Comment Set F2 – Southern California Edison

Attachment A SCE's Transmission Planning Assessment of the DEIR/DEIS's Phased Build Alternative

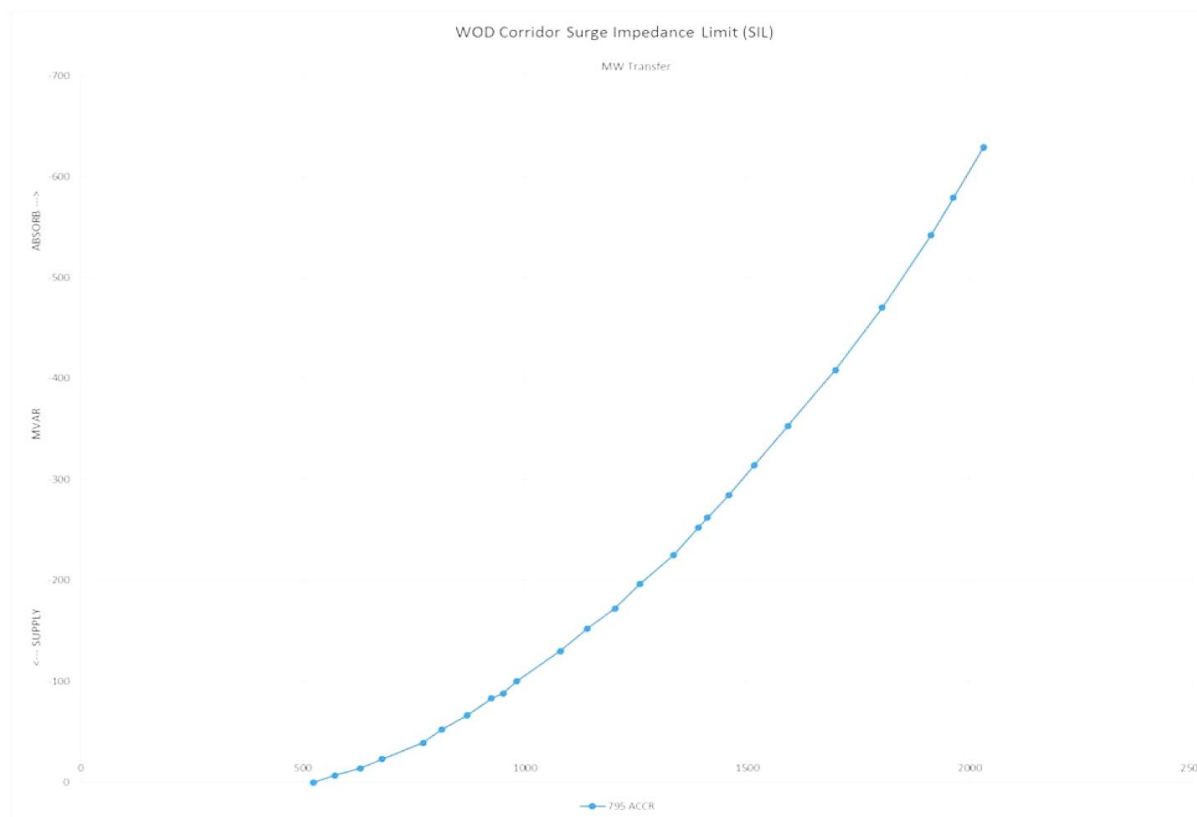
potential for system voltage instability. Thus, the 1,900 MW limitation safeguards against system voltage instability due to the excessively high MVAR losses on the 795 ACCR conductor.

As illustrated in the SIL chart below, the reactive losses on the 795 ACCR conductor are approximately 570 MVAR when the flow through the WOD corridor is approximately 1,900 MW.

Technical review by ZGlobal indicates that the MVARs consumed by the four circuits of the West of Devers corridor using 795 ACCR conductor would be as follows:

■ Devers-Vista	72 MVARs
■ Devers-San Bernardino	49 MVARs
■ Devers-El Casco-San Bernardino	50 MVARs
■ Devers-TOT185HS-Vista	72 MVARs
■ Total:	243 MVARs

This means that the total of 570 MVARs mentioned in SCE comment regarding the Phased Build Alternative may be an overstatement of these losses.
